TRANSMISSION LOCKOUT KIT

Backing your M939-series 5-ton truck with the transfer gearcase in low range will crack the gearcase.

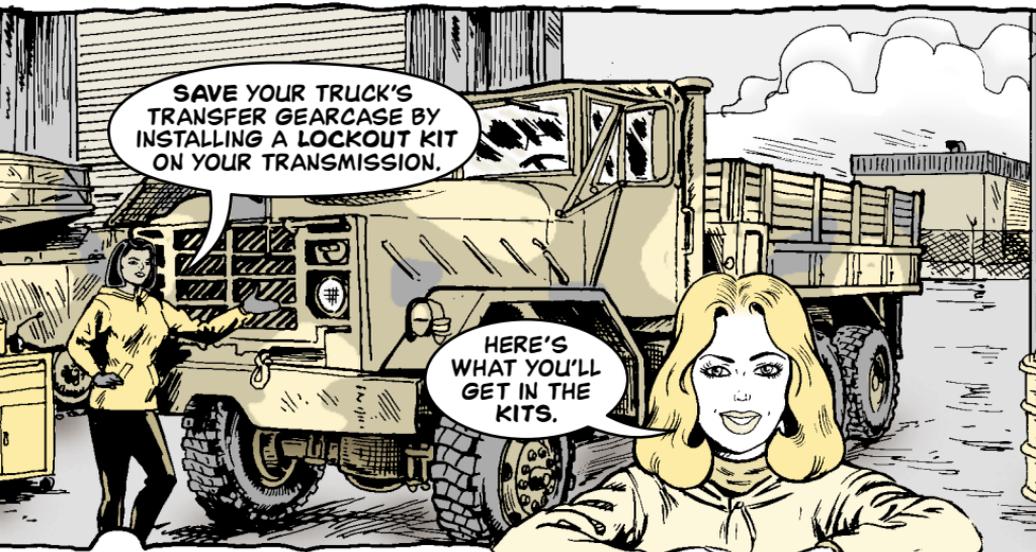
Units can now prevent this costly mistake by installing a lockout kit that will not let the driver put the transmission into reverse if the transfer is in low range.

If you own a basic M939-series or M939A1-series vehicle, use kit, NSN 2520-01-473-2742. M939A2-series vehicles need kit, NSN 2520-01-473-2744.
